Wollongong Local Planning Panel Assessment Report |13 July 2021

| WLPP No. | Item 1 |
|------------------|--|
| DA No. | DA-2021/337 |
| Proposal | Residential – alterations and additions, swimming pool and deck |
| Property | 13 Jennifer Crescent, Thirroul Lot 67 DP 219982 |

Figure 4: Site contours and house numbers from GIS Site contours are consistent with levels on survey provided (JRK Survey dated 13 July 2020)

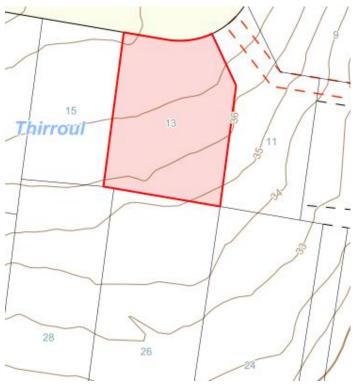
| Concerns raised in Submissions | Comment |
|---|--|
| | (For levels of the adjoining yard area refer to Site contours in Figure 4) Shadow diagrams show that there will be significant |
| | Site contours indicate that natural ground level of the area of open space between the dwelling at rear and the common boundary, and between the eastern dwelling and the common boundary, are at RL 35.0. |

$\textcircled{1}{1:100 @A2} \textbf{PROPOSED GROUND FLOOR PLAN}$

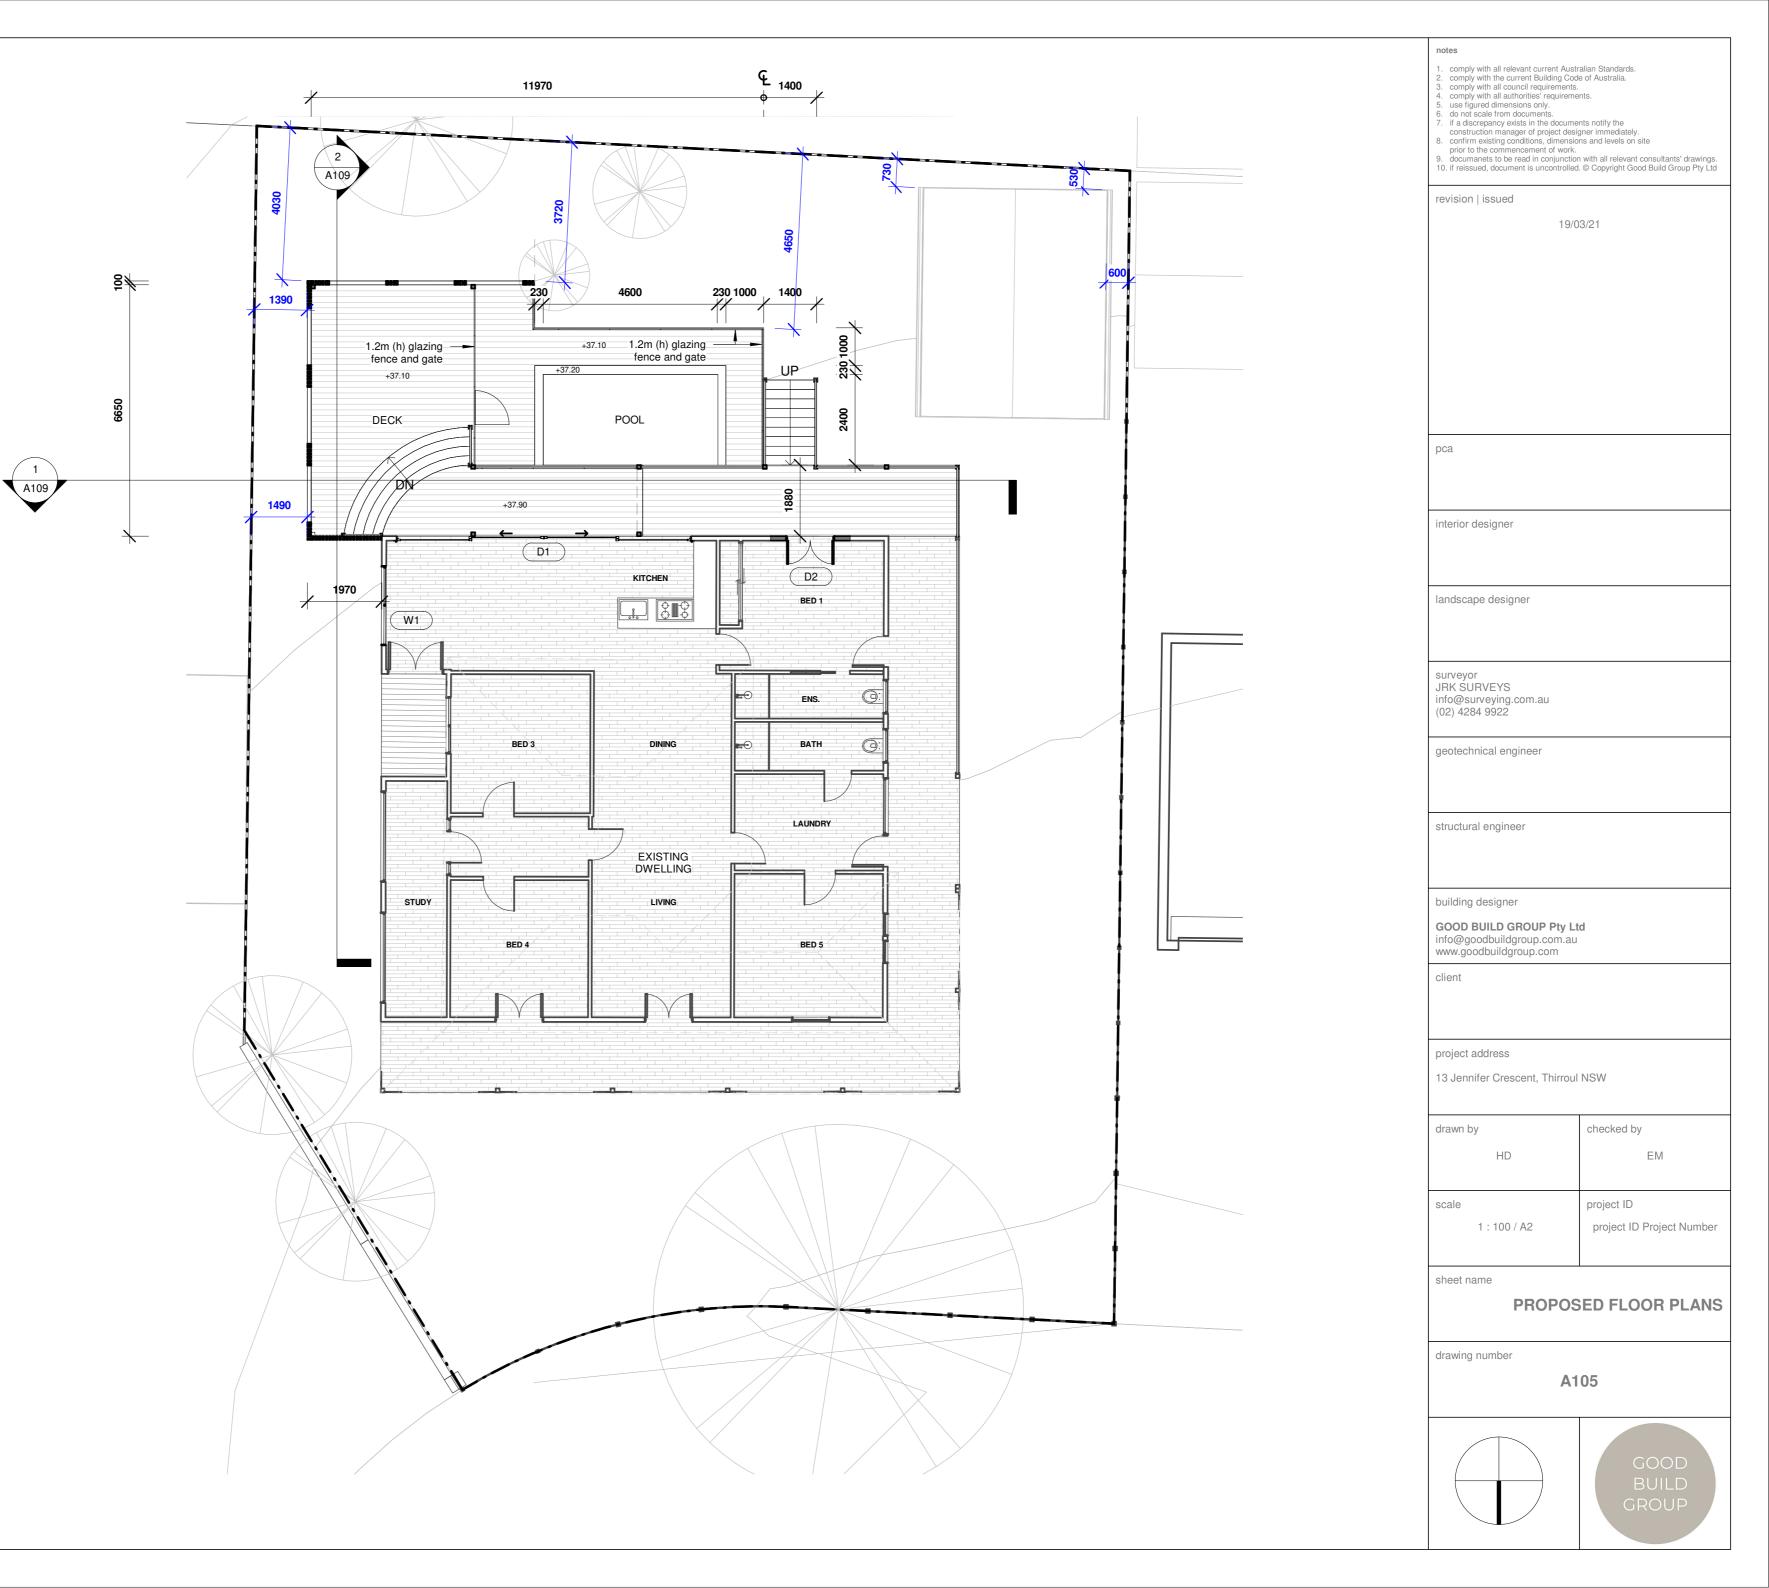
Refer setback dimensions on Drawing A105(Floor Plans) – Over a distance of 12 metres the rear setback is 4030mm, 3720mm & 4650mm. It is not over 5m for the majority of the site.
